Exhibit 3-1
Access & Circulation Plan

Exhibit 3-2
Four Lane Arterial Street Cross Section

Exhibit 7-8
Illustrative Commercial Concept

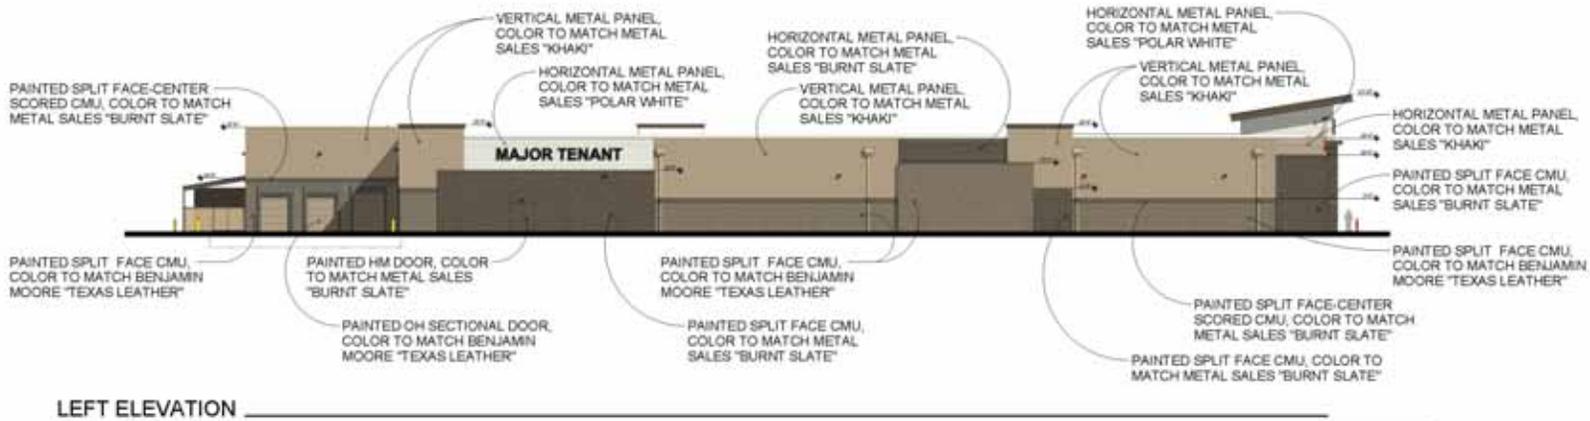
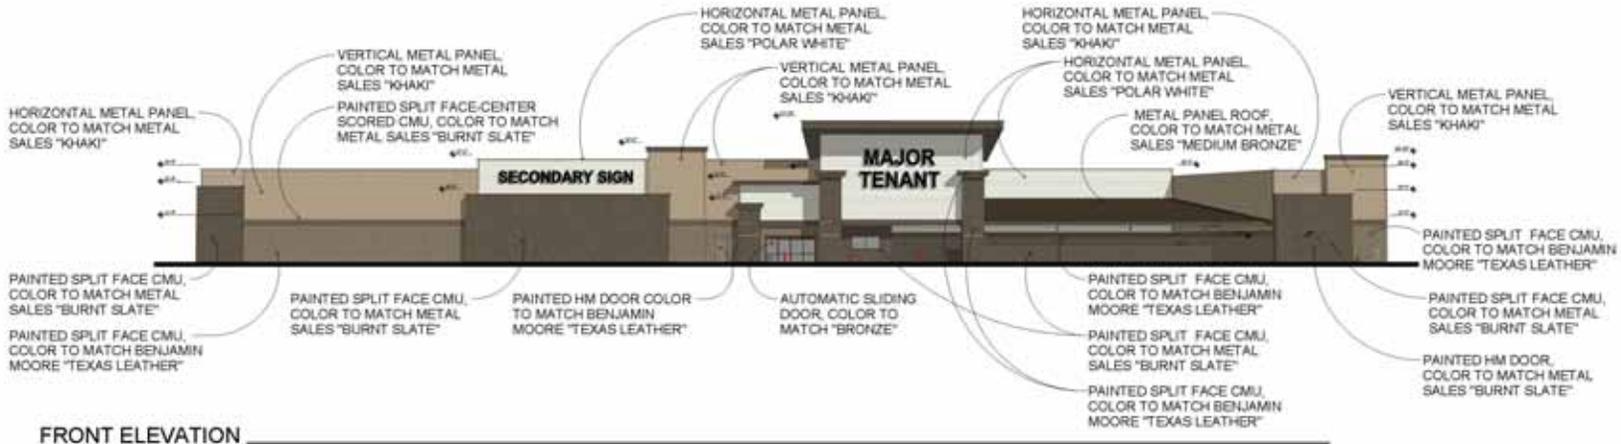
Proposed Addition

Proposed Addition
